Powerhouse Ultimo Renewal (SSD-32927319) | Response to Submissions- Addendum Transport Assessment

This document has been prepared by JMT Consulting to respond to the transport related feedback provided in City of Sydney Council and Transport for NSW submissions as well as the DPE issues letter.

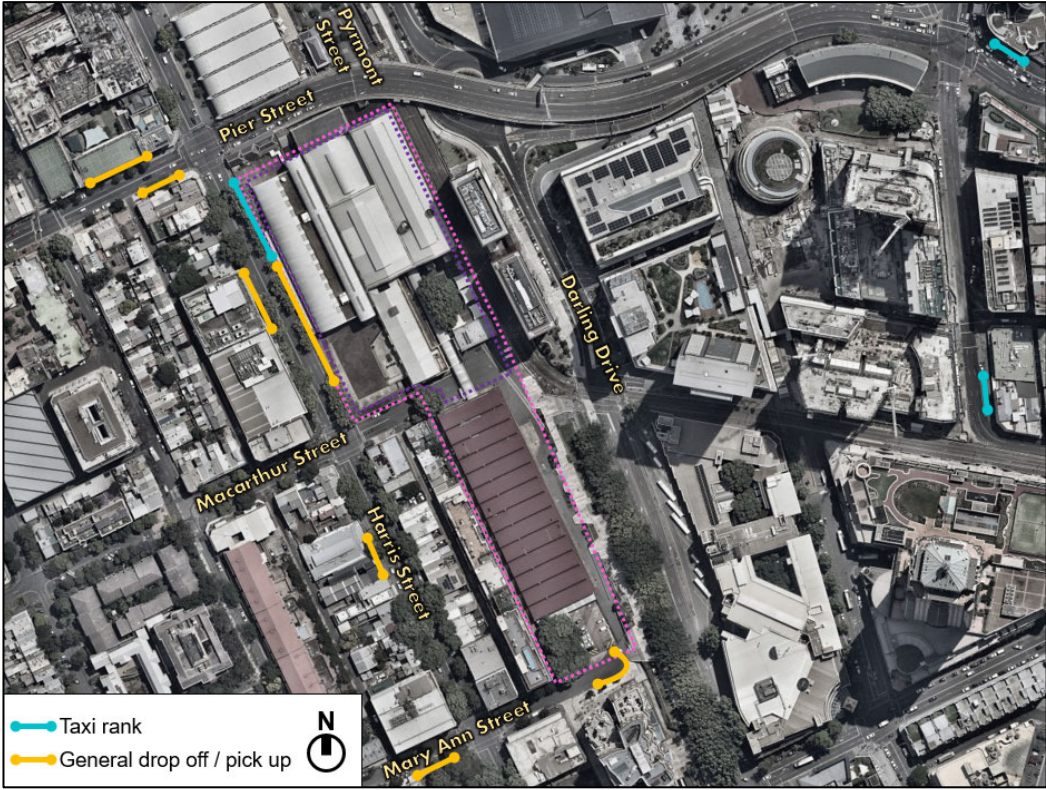
TfNSW Submission (Tab B – Advice)	Response
<p>Passenger Drop Off</p> <p>The Transport Assessment identifies that passenger drop-offs (i.e., taxi and uber etc) are forecast to increase as part of the proposed development however does not identify how they are proposed to be accommodated, including location/s.</p> <p>Further information should be provided on the type of facilities and locations for passenger drop-off, including the additional demand generated by the proposed development.</p>	<p>The Powerhouse Ultimo site benefits from a range of locations that provide for suitable drop off and pick up opportunities. These areas are identified in <i>Figure 2</i> and include taxi ranks as well as ‘No Parking’ zones that can be used for general drop off and pick up including for ride-share vehicles. The eastern side of Harris Street, directly adjacent to the Powerhouse Ultimo site, contains a large taxi rank capable of accommodating 5-6 vehicles at a time. Additional drop off areas in and around the site provide for capacity for approximately 40-50 vehicles for general drop off and pick up. This provision is considered more than adequate to accommodate the expected increase in peak hour demand of 17 passengers – equivalent to less than 10 vehicles when considering typical vehicle occupancies.</p>  <p><i>Figure 2 Drop off / pick up areas surrounding Powerhouse Ultimo</i></p>
